dsPIC30F1010/202X Rev. A1 Silicon Errata

The dsPIC30F1010/202X (Rev. A1) devices that you received were found to conform to the specifications and functionality described in the following documents:

The exceptions to the specifications in the documents listed above are described in this section. These exceptions are described for the specific devices listed below:

FIGURE 1: ADDITION OF 100 OHMS RESISTOR ON EXTREF PIN

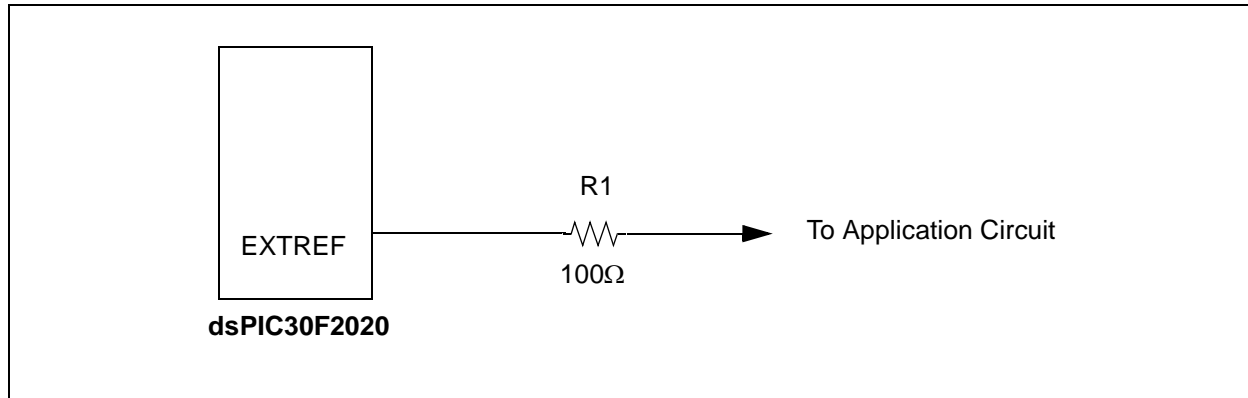
The EXTREF pin is susceptible to voltage spikes below V_{SS} , which induces negative current flow into the pin. A voltage below V_{SS} on any I/O pin is outside the operating specification of the device; however, the device is designed to tolerate small voltage and current transients without experiencing detrimental effects. The EXTREF pin is more susceptible to negative current spikes than the other pins on the dsPIC1010/202X Rev. A1 devices.

If the EXTREF pin is used in any of the configurations shown in Table 2, it is recommended that a 100 ohms 1/8W resistor be added in series with the EXTREF pin (see Figure 1).

The addition of the 100 ohms resistor effectively makes the EXTREF pin as robust as the other pins on the device with respect to tolerating voltage and current transients. In most of the configurations shown in Table 2, the 100 ohms resistor will have little effect on the operation of the pin. An exception to this is when the pin is configured as the comparator reference, EXTREF. Adding a resistor in series with the reference voltage will cause a slight offset in the gain of the comparator DAC. This gain offset is related to the voltage drop across the 100 ohms resistor.

FIGURE 2:

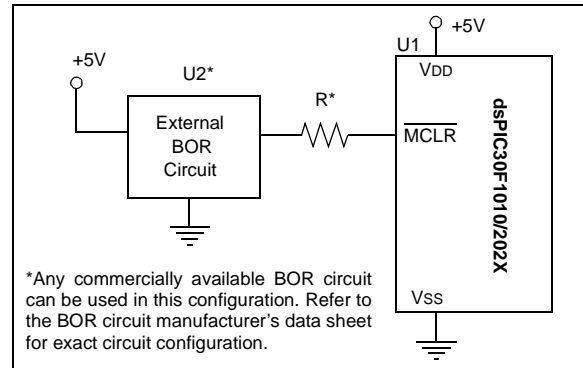
A brown-out event occurs when VDD drops below the minimum operating voltage for the device but not all the way down to Vss. When the dsPIC DSC SMPS device is running with the PLL enabled and a brown-out event occurs, the device may stop running and the MCLR pin will not reset the device. If this occurs, the device can only be reset by cycling power to the VDD pins.

It is recommended that an external Brown-out Reset (BOR) circuit be used to hold the device in Reset during a brown-out event, to overcome this problem. The external BOR circuit will use the MCLR pin to hold the device in reset. The following work around, in combination with the external BOR circuit, will ensure that the device is cleanly reset after a brown-out event occurs.

The dsPIC DSC SMPS device must be powered up with the PLL disabled, the Fail-Safe Clock Monitor enabled, and clock switching enabled. The PLL should be enabled in software via a clock

switch after the device is reset (refer to **Section 29. "Oscillator"** (DS70268) in the "*dsPIC30F Family Reference Manual*" (DS70046) for details on clock switching). This ensures that the MCLR pin is functional and that the device can be reset by an external BOR circuit (see Figure 2).
